Policy Review Committee Action Report for the August 16th, 2016 meeting held in the Council Chambers at 7:00 p.m.

Topic SWM Pond – Roy Brown Park

Topic Subdivision Application

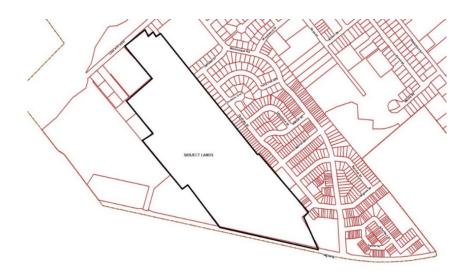
An application for conceptual subdivision has been submitted to the Town of Carleton Place. The subject lands are located between Highway 7 and Lake Avenue West. The lands are approximately 24.8ha with 98.5, of frontage on Lake Avenue West. The lot depth is approximately 1,106.7m. The subject lands are described as Con 11, NE ½ of Part Lot 12, 27-R5504, Parts 2, 3 and 3 and are illustrated below:

The previously distributed concept plan shows a mix of residential uses (single, semidetached and towns) and a storm pond (proposed to be located on adjacent Town lands). There has been no official subdivision application filed, however this is an opportunity to comment on the general layout and features of the proposed subdivision.

The proposed subdivision layout indicates that there will be 10 streets within the subdivision, street 9 being the extension of Johnston Street. Streets number 2, 6 and 10 will provide access from the adjoining subdivision, allowing linkages through the proposed subdivision towards Roy Brown Park as well as to the commercial block through Street 1. Street 3 will also provide access into Roy Brown Park.

In an effort to increase active transportation, and in order to meet development requirements, a 2.5 metre pathway is shown along street 3 linking directly into Roy Brown Park and along streets 6 and 9. Sidewalks will be required on one side of the remaining streets.

A stormwater pond, which will be used by the developer for this proposed subdivision, the Town of Carleton Place (for drainage of Roy Brown Park) and the commercial property, is proposed to be constructed on the adjacent Town owned lands located in Roy Brown Park.

Parking has been a problem in some existing townhome neighbourhoods.

THAT the Town supports the conceptual plan as submitted provided it is refined to:

- improve on-street parking opportunities near townhomes;
- include appropriate tree planting, landscaping and fencing;
- ensure pathways along the street are a pleasant landscaped space; and
- > ensure the SWM pond is designed to meet all regulations, provide treatment and function properly.

THAT the Town supports the conceptual plan as submitted provided it is refined to:

- improve on-street parking opportunities near townhomes;
- include appropriate tree planting, landscaping and fencing;
- ensure pathways along the street are a pleasant landscaped space; and
- ensure the SWM pond is designed to meet all regulations, provide treatment and function properly.
